**El Sur Ranch**  
**Water Right Application No. 30166**  
**Final Environmental Impact Report**  
**SCH No. 2006061011**  
**Monterey, California**

*Prepared for:*  
**California State Water Resources Control Board**  
**Division of Water Rights**

**May 2011**

**Figure 9: Cliffs at El Sur Ranch Pasture 7 – October 2005**  
**Close up of groundwater sapping erosion causing scalloped erosion head scarps**

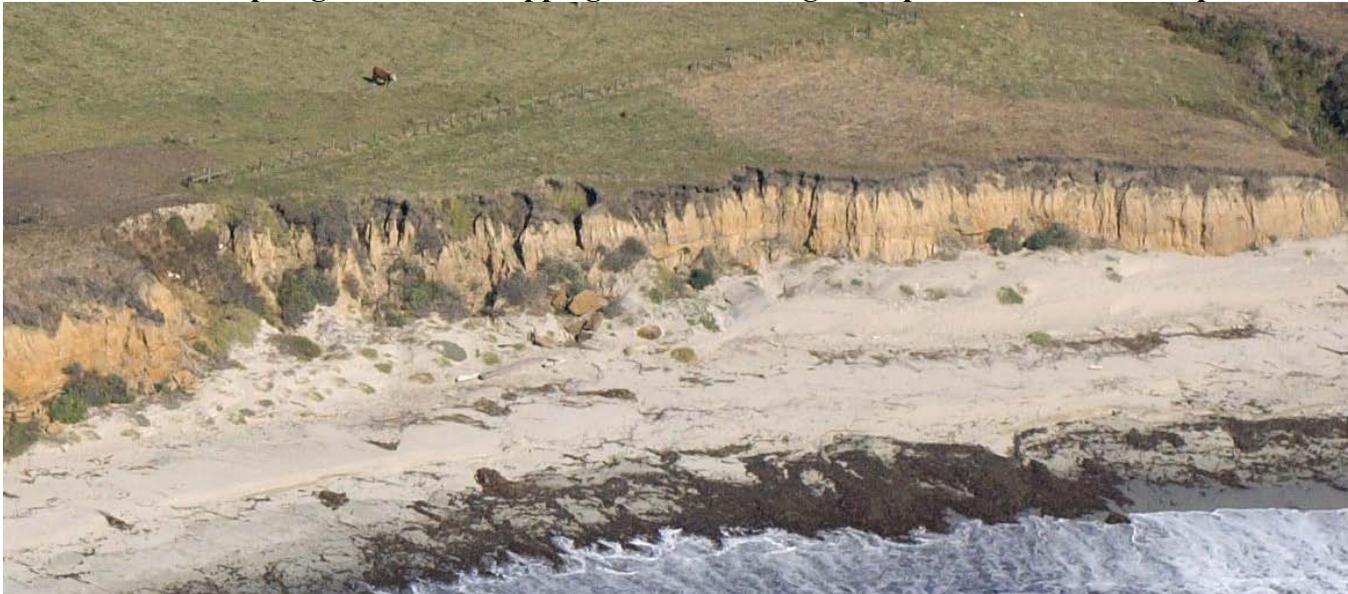
- a) Figures 4 through 10 show the section of the bluffs adjacent to pasture 7 and Swiss Canyon. This area lies approximately between the bluff survey points #1 and #2 in Hanson’s 2006 (2007c) monitoring study. Unfortunately, the older images are not as clear as the more recent ones, but I think that the two larger arcuate gully head scarps can be seen in the 1979 and 1989 image as well as a bluff that appears to have a shallower slope than in the later images. In the 2005 and 2008 images, Figure 7 through 10, the bluff shows a distinctive set of scalloped or “theater-headed” scarps at the head of a number of gullies. The number and density of these scalloped shaped gullies appears to have increased significantly between 1989 and 2005. The bluff erosion continued between 2005 and 2008, but because of the shorter period of time the change is less apparent.
